Service Bulletin

Revised battery monitor board available to fix battery issues with crystal lead generator batteries

DX-D 100 / DX-D 100 Wireless

Title:	DX-D 100 - Service Bulletin No. 79 - Revised battery monitor board available to fix battery issues with crystal lead batteries
Livelink ID:	53918976
Version#:	7
Version Date:	2016-04-07 01:56 PM CET
Status:	Approved on 2016-04-11 03:21 PM CET
Owner:	Carsten Bockel (awyuq)
Created By:	Carsten Bockel (awyuq)
Created Date:	2016-03-07 10:00 AM CET
PDF Creation Date:	2016-04-11 03:21 PM CET

Figure 1 – Old battery monitor board

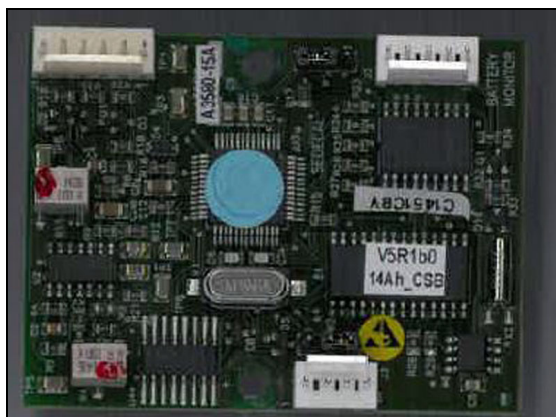
Symptom Fully charged unit displays low battery message after 12 exposures at a new system with generator batteries with lead crystal technology. Overall only 60 to 80 exposures possible instead of 200.

Cause Software issue of the battery monitor board.

Solution Updated battery monitor board software fixes that issue. The latest software is installed on the battery monitor board with version V5R1b2

Replace the battery monitor board with the revised board which included the new software.

- (1) Replace the battery monitor board with the revised board delivered with the spare part kit. For replacement instructions refer to document DX-D 100 / DX-D 100 Wireless Mobile X-Ray Unit - Service Manual, Chapter Troubleshooting, Section 2.2.3 and 2.7, Document ID [41600560](#).
